Re: Supplemental Filings for Pending Special Permits/Site Plan Application  
164 Grove Street, Franklin, MA

**Re: 164 Grove Street  
Site Plan Peer Review Update**

We have received the peer review letter from BETA Group, Inc. dated September 24, 2020 in regards to the revised documents for the proposed Site Plan Approval application, "**Permit Site Development Plans - 164 Grove Street, Franklin, Massachusetts**" and offer the following responses.

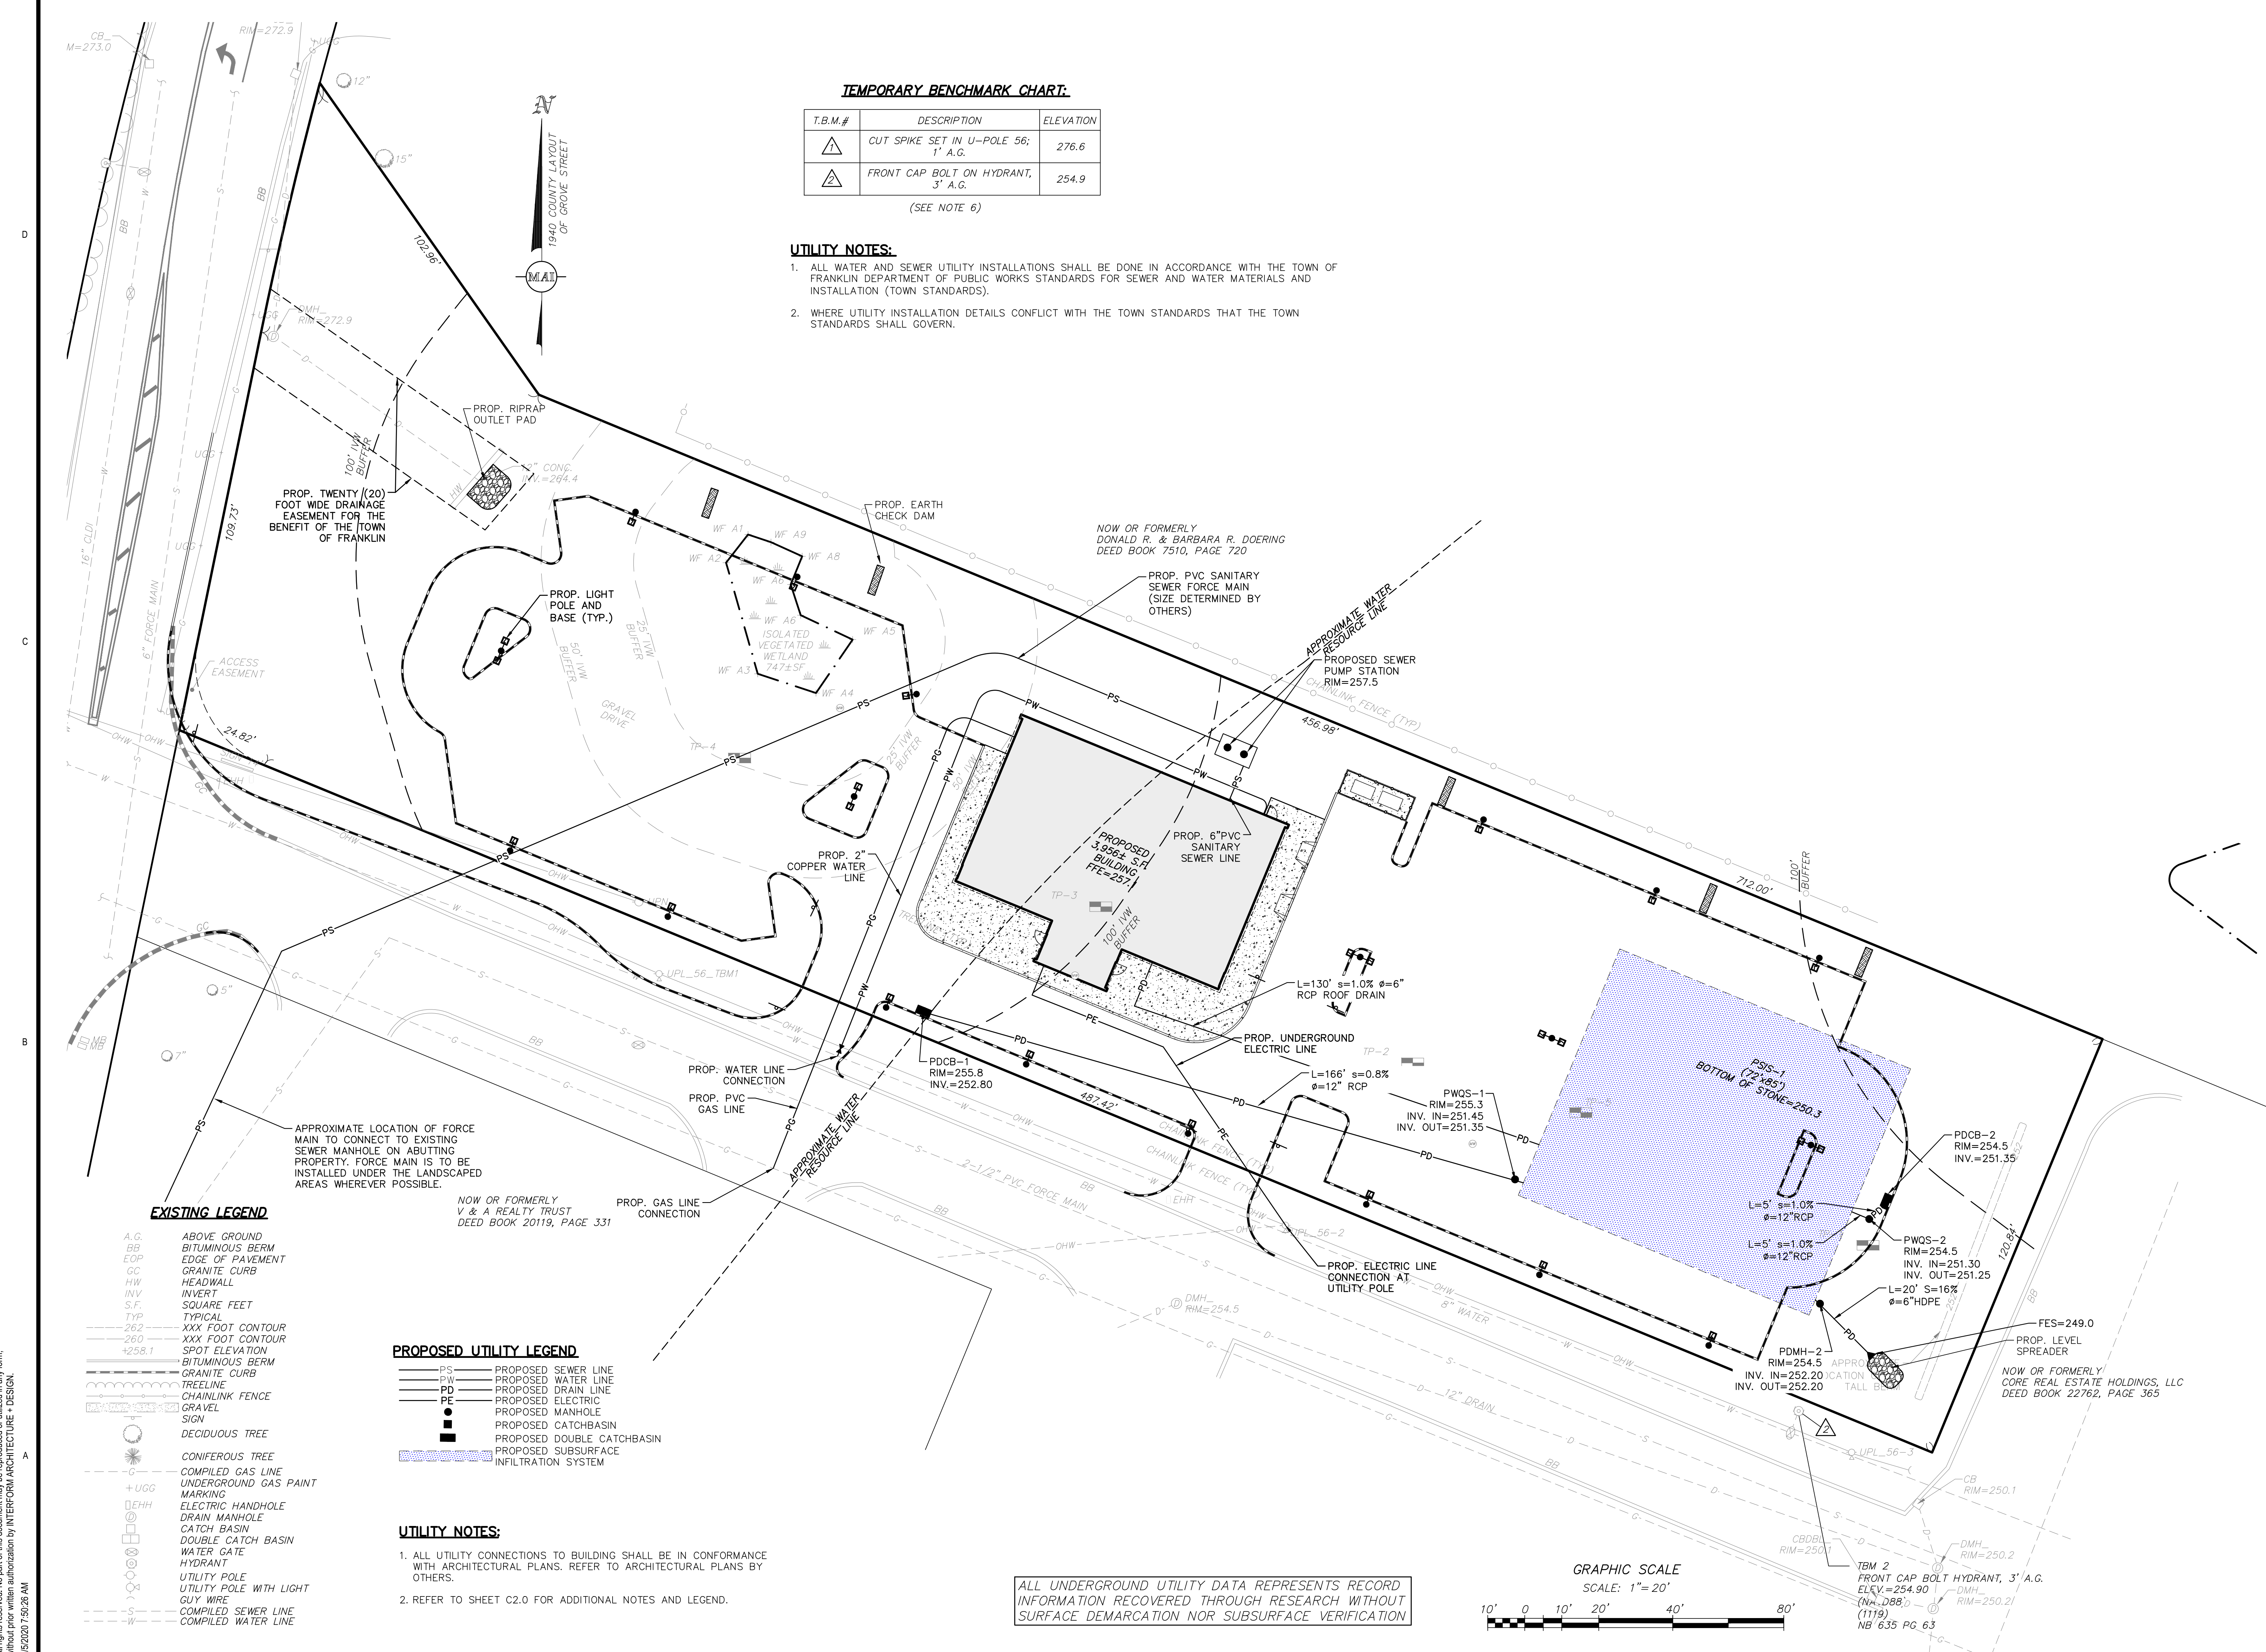
- U1. Provide a note that all water and sewer utility installations shall be done in accordance with the Town of Franklin Department of Public Works Standards for Sewer and Water Materials and Installation (Town Standards). Also note that where utility installation details conflict with the Town Standards that the Town Standards shall govern. *MAI: The above requested note has been added to the plan set, refer to Sheets C 2.0 and C 3.0. Notes have been added that show where utility*

- U2. Provide size and material information for proposed sewer force main and water line(s). *MAI: The size and materials of the sewer and water lines have been added to the plan set, refer to Sheet C 3.0.* **BETA2: Information provided. In accordance with Town Specifications, revise material of water service line to copper if length is 100 feet or less (corporation stop to curb stop and curb stop to building) and HDPE otherwise.** *MAI2: The water line has been revised to be copper.* **BETA3: Material revised – issue resolved.**

LANDSCAPE PLAN

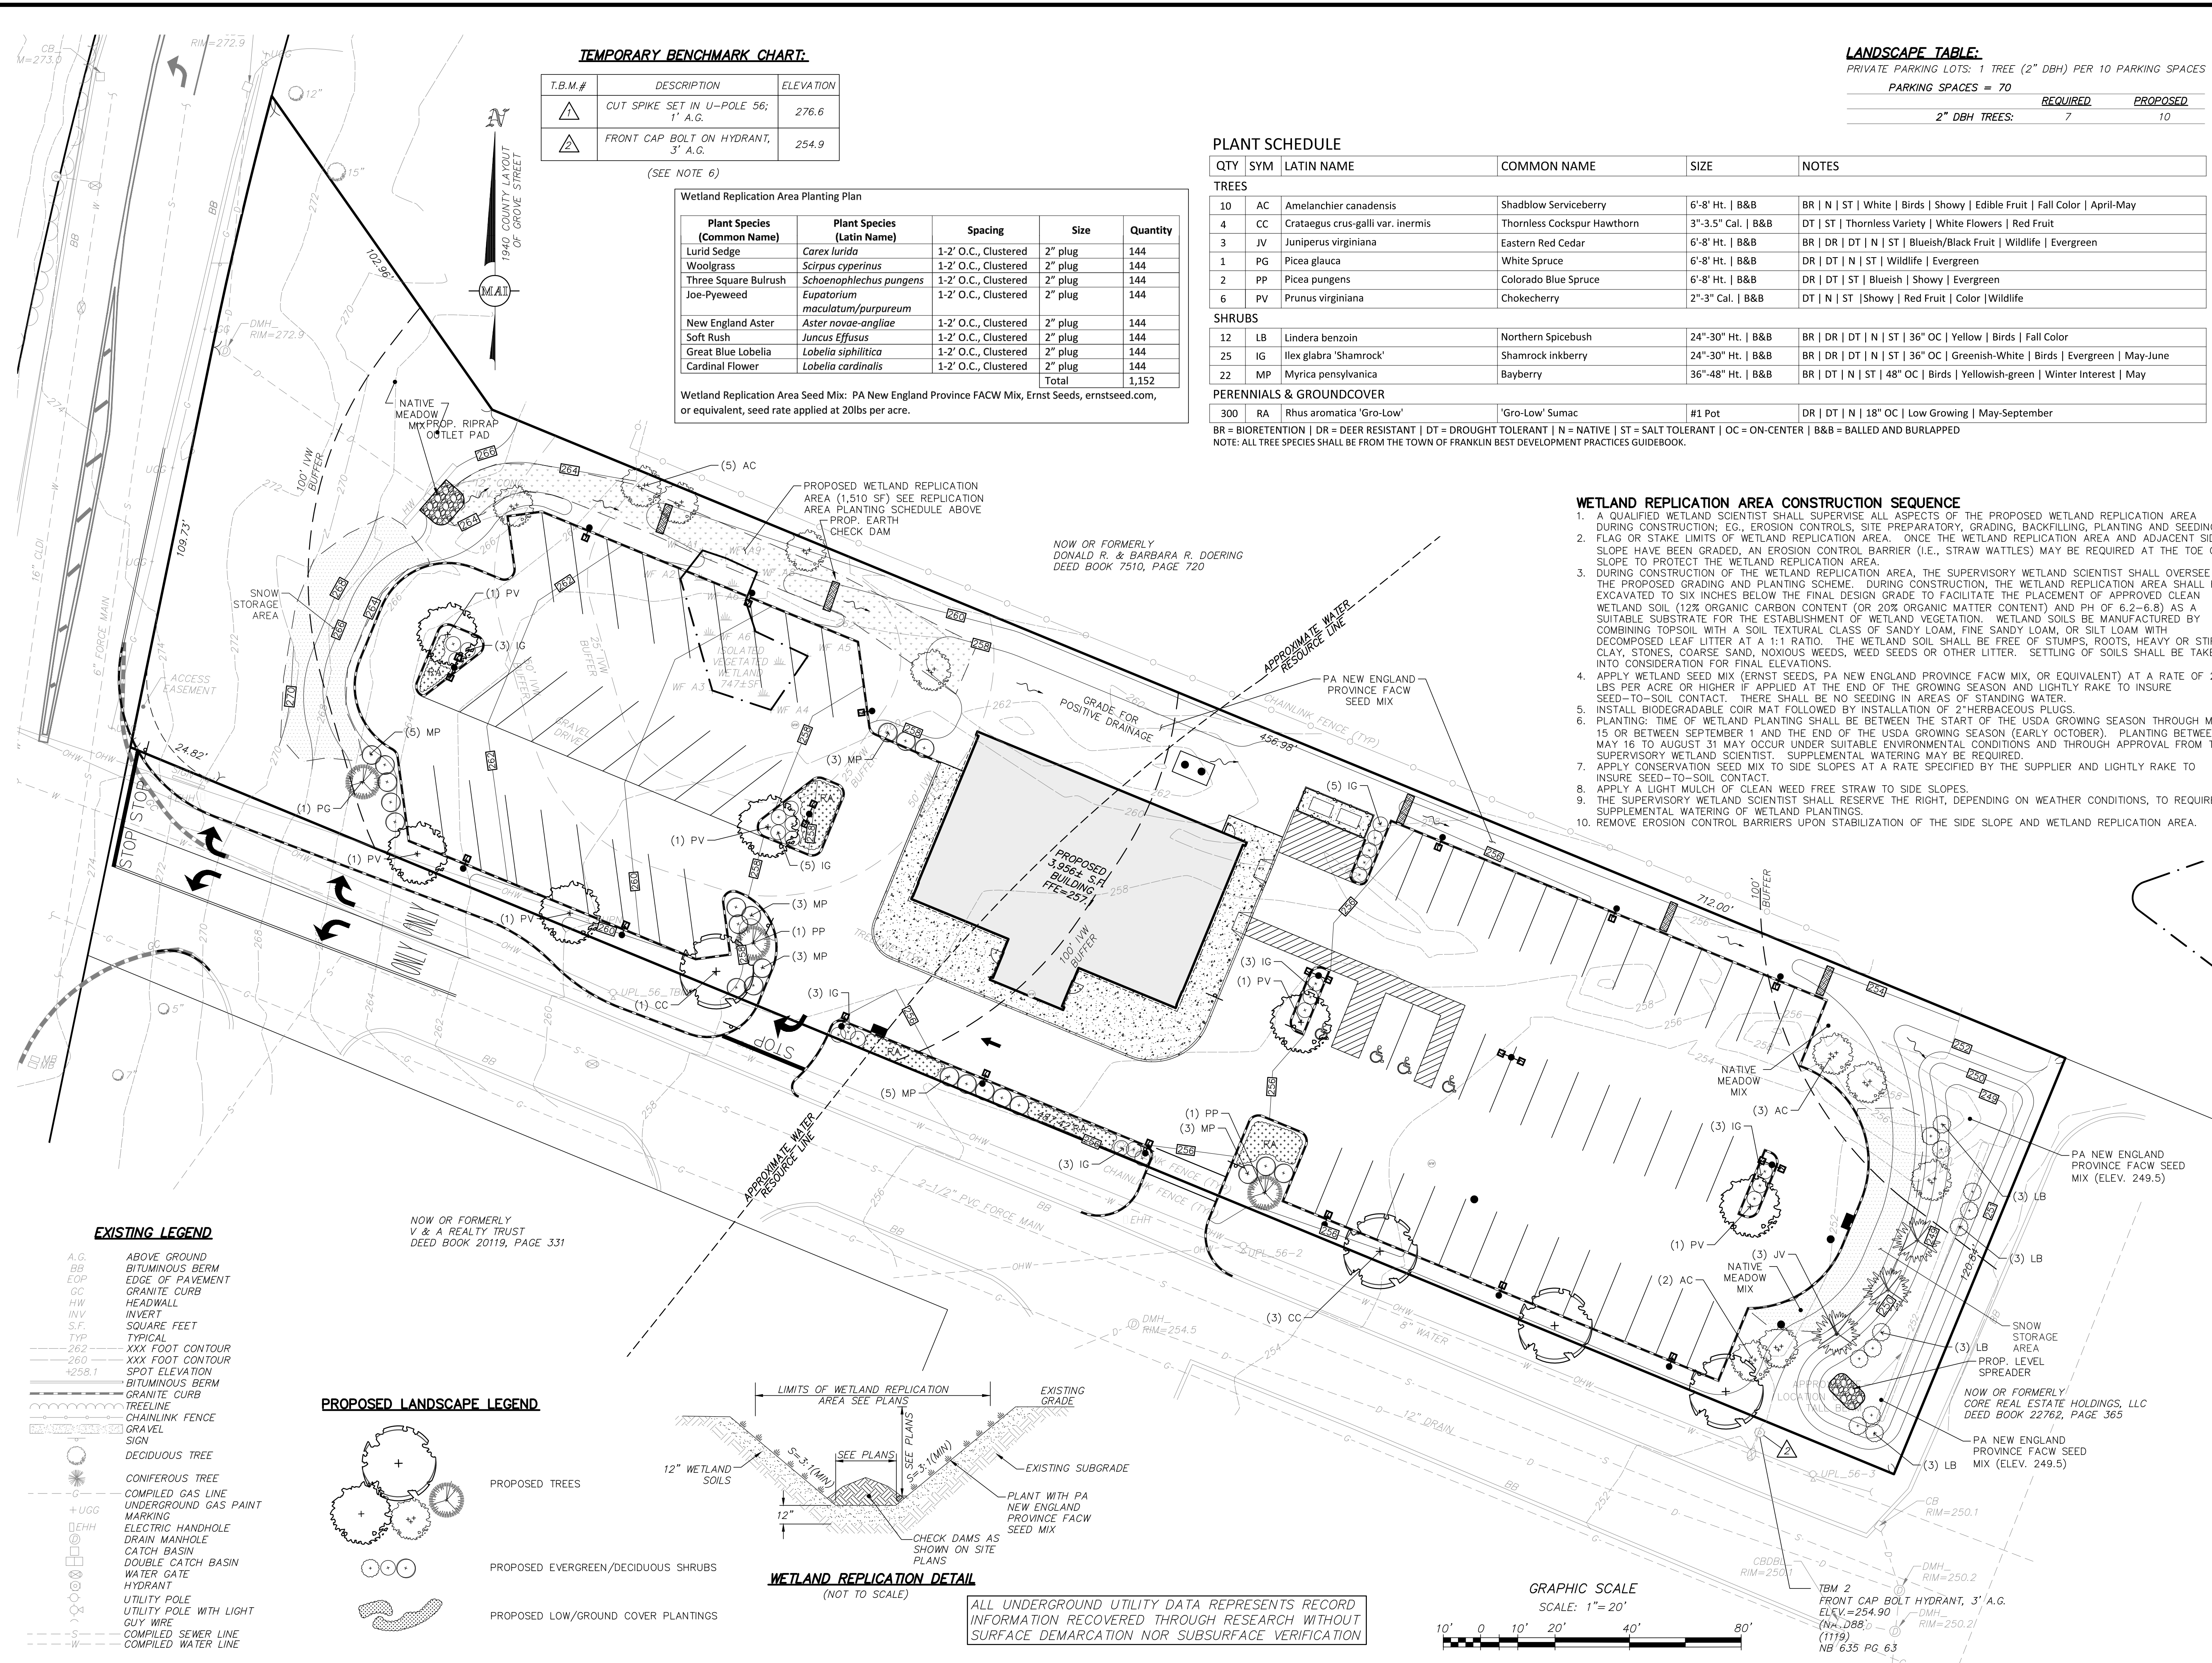
- G4. Recommend revising snow storage areas to maintain clear flow path within swale along the northerly property line. Consider providing additional snow storage along the southerly curb line. *MAI: The snow storage locations have been adjusted accordingly, refer to Sheet C 4.0. **BETA2: Snow storage area revised – issue resolved.***
- G5. Provide a note to indicate that tree species shall be from the Town of Franklin Best Development Practices Guidebook. Also confirm the proposed plantings meet this requirement. **BETA2: No response provided – issue remains outstanding.** *MAI: A note has been added to the landscaping plan. Additionally, the tree species have been updated and now specify trees that are listed in the Town of Franklin Best Development Practices Guidebook. **BETA2: Note provided – issue resolved.***
